MODEL: 2016 Ninja ZX-10R & Ninja ZX-10R ABS

CAM CHAIN TENSIONER NOISE

FACTORY AUTHORIZED REPAIR

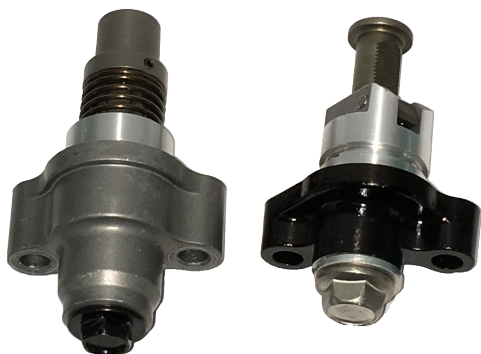
On eligible units, customers may complain of a loud metallic noise coming from the camshaft chain tensioner. This typically occurs when the engine is hot between 2,000 and 4,000 RPM, or on engine over run (although it may occur at other RPM).

Kawasaki has initiated a FAR campaign to repair all eligible units. The repair consists of replacing the cam chain tensioner.

Replace the cam chain tensioner only if the unit exhibits a noisy cam chain tensioner and has the original cam chain tensioner installed.

Remove original Tensioner

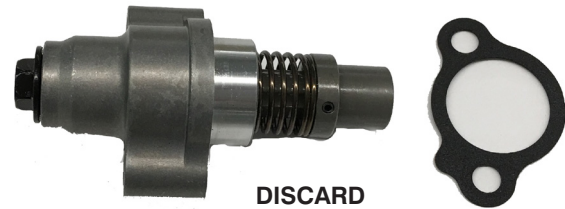
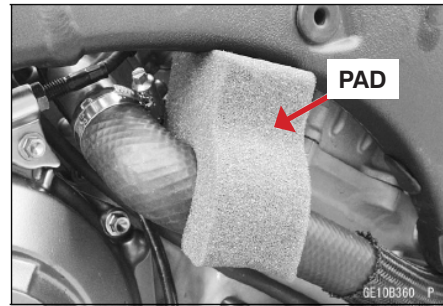
- Remove right hand, lower fairing.
- Remove pad.
- Remove and discard original tensioner and gasket as outlined in the service manual.
- Remove all traces of the tensioner gasket.

New Camshaft Chain Tensioner Installation Procedure.

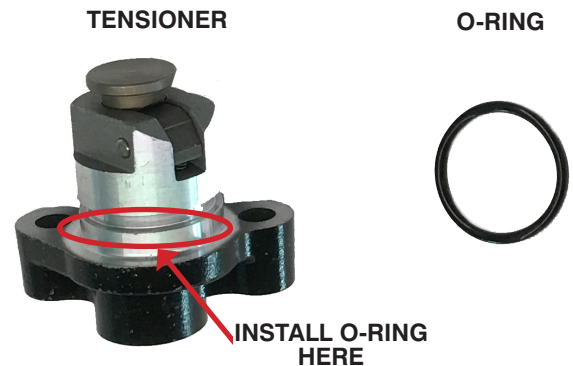
- Install the O-ring on the new tensioner.
- Apply grease to the O-ring.

- Release the stopper and push the push rod into the interior of the tensioner body until it bottoms out.
- Install the tensioner body so that the stopper faces upward
- Tighten the tensioner mounting bolts to 9.8 N•m (1.0 kgf•m, 87 in•lb).

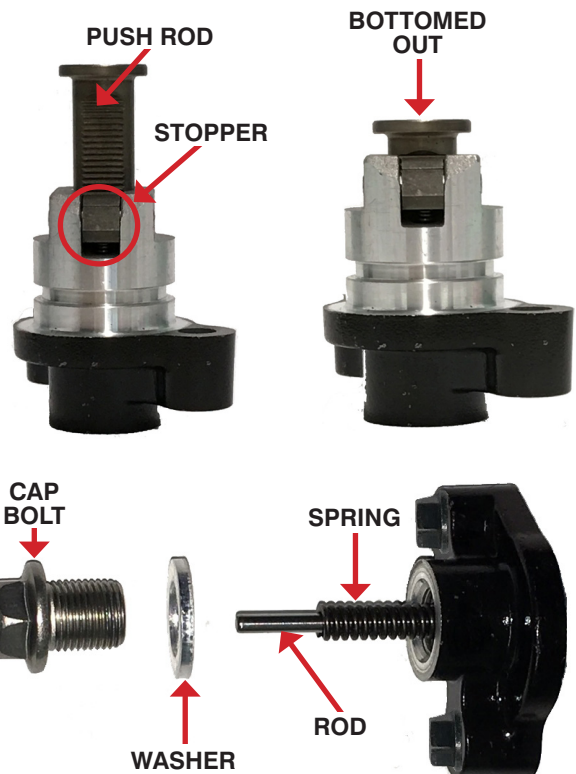
- Install the rod into the spring then install the spring and rod into the tensioner body.
- Install the washer onto the cap bolt.
- Install the cap bolt (with washer) into the tensioner body.
- Tighten the cap bolt to 20 N•m (2.0 kgf•m, 15 ft•lb).
